SERVICE BULLETIN

M-1250A

2009 FLTRSE3 BLADE WHEEL SAFETY RECALL 0140

Purpose of Revision

Figure 1. Manufacturing Code Location

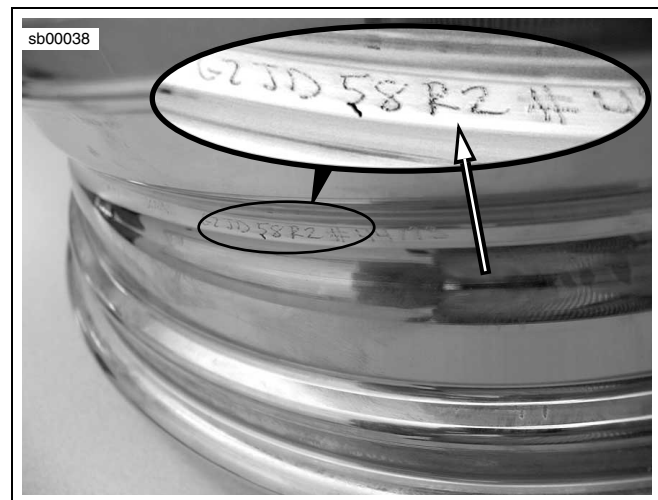
3. See Figure 1. The manufacturing code is a hand-engraved number located in the drop-center area of the wheel. Examine only the code described in Table 1-2.
4. Identify the manufacturing code. Refer to Table 1-2. A wheel is part of this recall and requires replacement if:
 - An R1 or R2 are the 22nd and 23rd characters from the left (including # symbols).
 - The "R" is an upper case letter.
 - The "R" is next to a "2" or a "1" – there are no additional digits or letter characters between them.

5. If characters 22-23 are R1 or R2, replace the wheel and file a warranty claim as outlined in the appropriate *Replacement* Credit Procedures that follow. If characters 22-23 are not R1 or R2, file a warranty claim as outlined in the appropriate *Inspection* Credit Procedures that follow.
6. Install the tire and wheel. See the service manual.
